## TRUCK, GENERAL MAINTENANCE, LIGHT, WINCH, MC2 – LAND ROVER 110 6X6

### REPLACEMENT OF MAIN SWITCHBOARD (CIRCUIT BREAKER PANEL) EARTH TERMINAL SCREW

## MODIFICATION INSTRUCTION

Figure 1 – Earth Terminal Screw

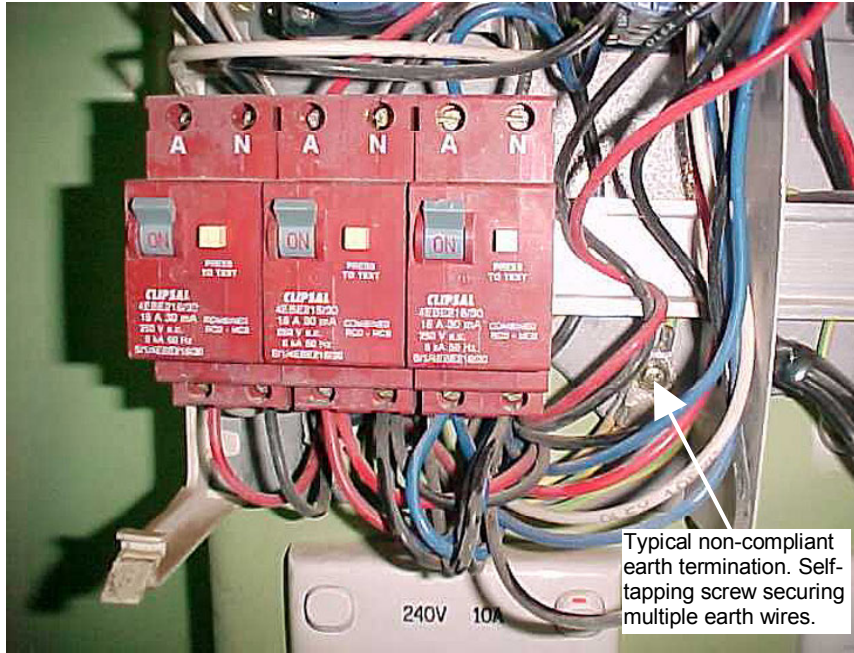
2. Various types of main earth terminal screws are fitted to these vehicles and, generally, they are self-tapping type of screws screwed into the rear metal cover plate of the switchboard (see Figure 1). This self-tapping screw is also used as the main earth terminal for a number earth wires entering the switchboard.

3. This self-tapping screw method of earthing multiple earth wires is not compliant with the requirements of AS/NZS 3000 and does not provide a reliable common earth point.

- a. Disconnect batteries and external power supply cables.
- b. Remove the circuit breaker panel cover (refer to EMEI Vehicle G 243).
- c. Remove self-tapping main earth screw from switchboard rear metal panel and remove and discard crimp lugs from the earth wires.
- d. Make an earth lead using 100 mm length of 2.5 sq mm green yellow/wire (Table 3, Item 1) and crimp lug (Table 3, Item 2). Using the self-tapping earth screw, connect this

earth lead to the switchboard rear metal panel.

- e. Strip insulation from all earth wires, twist them together and terminate them into the tunnel lug (Table 3, Item 3).
- f. Using wire ties (Table 3, Item 4), tie and secure the earth wires into the switchboard wiring loom.
- g. Replace the circuit breaker panel cover (refer to EMEI Vehicle G 243).
